<b>IWPP696/18 Agenda Item 1</b>	<b>Planning Proposal</b> 1-5 Chester Street Annandale
<b>Description:</b>	Make amendments to the Leichhardt Local Environmental Plan 2013 to rezone the site from Light Industrial to Medium Density Residential, increase the Floor Space Ratio and introduce a Maximum Building Height control.

<b>INNER WEST COUNCIL</b>	
<b>PLANNING PROPOSAL REPORT</b> <b>From the Planning Operations Team – Strategic Planning</b>	
<b>Planning Proposal No.</b>	IWC_PP_2018_02
<b>Address</b>	1 - 5 Chester Street, Annandale
<b>Proposal</b>	Make amendments to the Leichhardt Local Environmental Plan 2013 to rezone the site from Light Industrial to Medium Density Residential, Increase the Floor Space Ratio and introduce a Maximum Building Height control.
<b>Main issues</b>	Prematurity in relation to the Parramatta Road Corridor Urban Transformation Strategy Implementation Plan staging; Loss of industrial land; Bulk and scale.
<b>Recommendation</b>	That the Panel provide advice to Council on the merits of the Planning Proposal.

Figure 12 - Extract from the proponent's design scheme with a 5 storey building facing Chester street, 6 storey building facing Johnstons Creek communal open space on the ground level and roof top level.

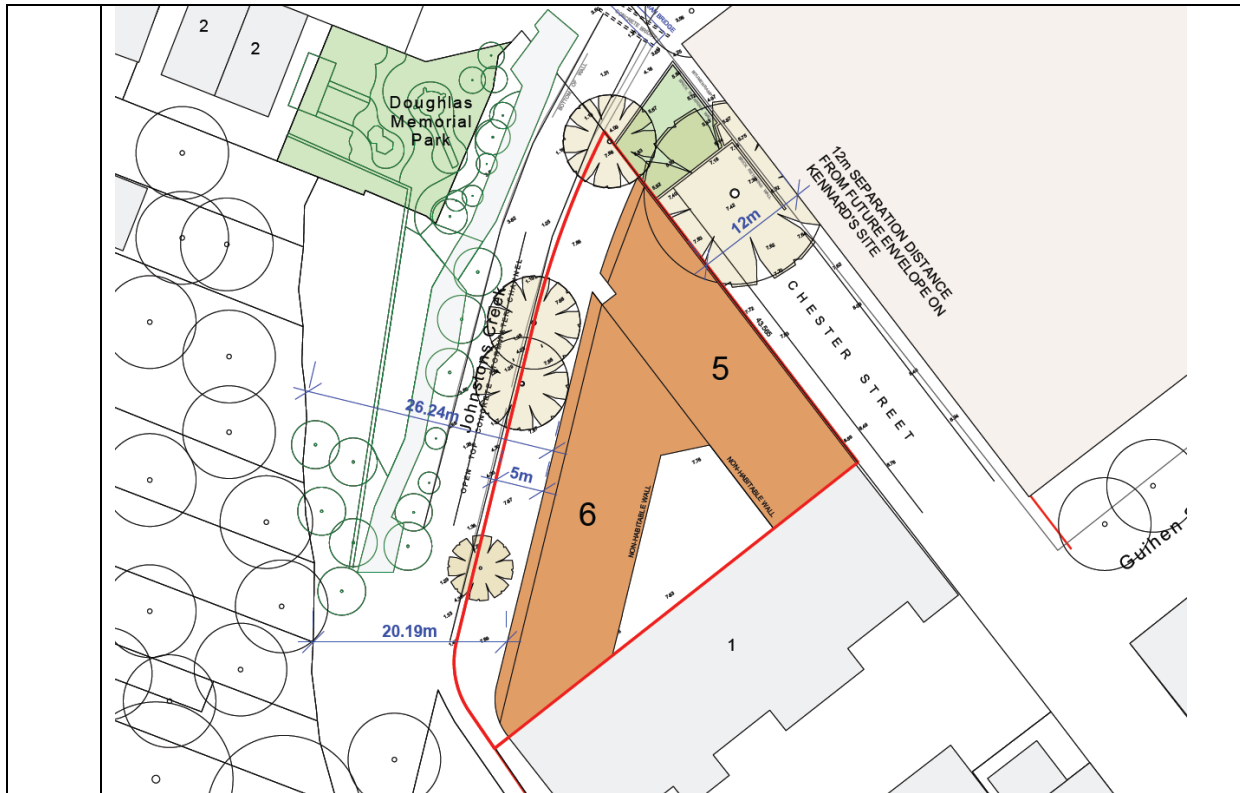
The key concerns in relation to the proposed concept design are detailed below:

- **Overshadowing:** The proposed communal open space on the ground level of the development is completely overshadowed in mid-winter between 9 am to 3pm as shown in the image below. This would adversely impact the amenity of the future residents of the development.

In order to resolve the above design issues, the proposal would have to be revised to reduce the bulk and provide adequate setbacks, articulations and transitions. The recommended density of 1.5:1 and building height of 17m in PRCUTS are appropriate development controls for the site. These would adequately resolve the above issues and achieve a built form that is consistent with the existing and desired future character of the area.

Figure 15 - Extract from proponent's Urban Design scheme indicating the relationship of the built form along Chester Street with the adjacent building at No. 8 Guihen Street. Red blurb indicating the potential street widening on the adjacent site.

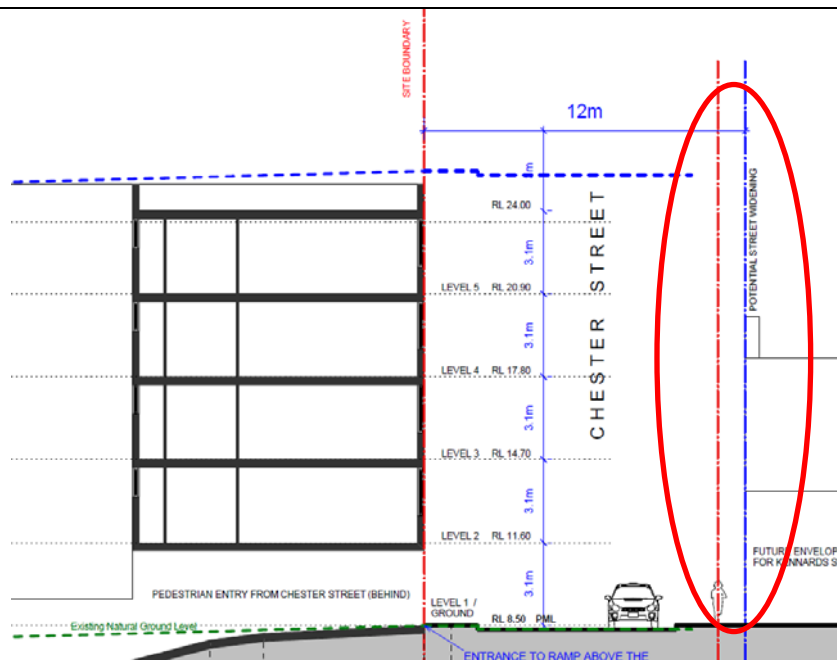
The ADG requires a separation distance of 18m between habitable rooms/balconies or 12m between habitable and non-habitable rooms for buildings between 5 to 8 storeys. In this regard, the proposal would provide an inadequate separation distance to 8 Guihen Street and restrict its development potential by assuming that this site in another ownership would accommodate any necessary widening of Chester Street. This approach is unacceptable and the proponent should work within the constraints of their own site without relying on the contribution of setbacks/ widenings from adjacent sites.
